UNITED STATES PATENT AND TRADEMARK OFFICE

Office Action Summary

10/821,619

FIG. 18

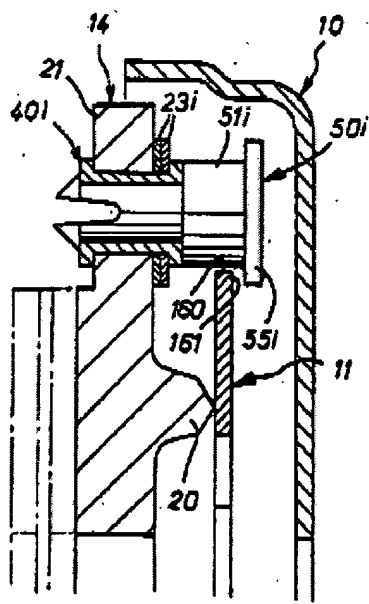
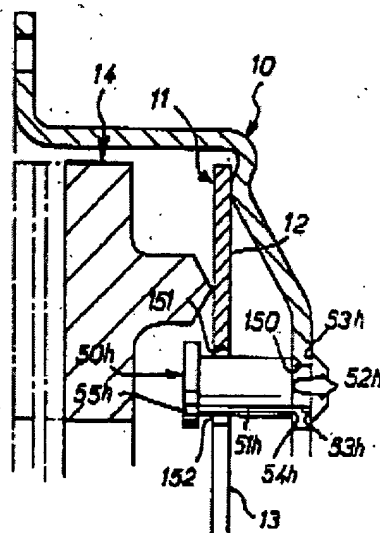
Beneton discloses a repeatedly engageable and disengageable friction clutch comprising a housing (184, 196), a predetermined axis (152), pressure plates (179, 180), prestressed/predeformed (paragraphs 58, 64, and 80) diaphragm springs (188, 194) with an annular portion and tongues (paragraph 55), a ring shaped supporting portion, tensioning means, tensioning means (interference between diaphragm and clutch housings), wear compensating means (201, 202), first and second ring shaped fulcrums (189, 191, 194, 195), first and second annular portions, means for disengaging the clutch and means for deforming the diaphragm spring (185), and leaf springs (181, 182).
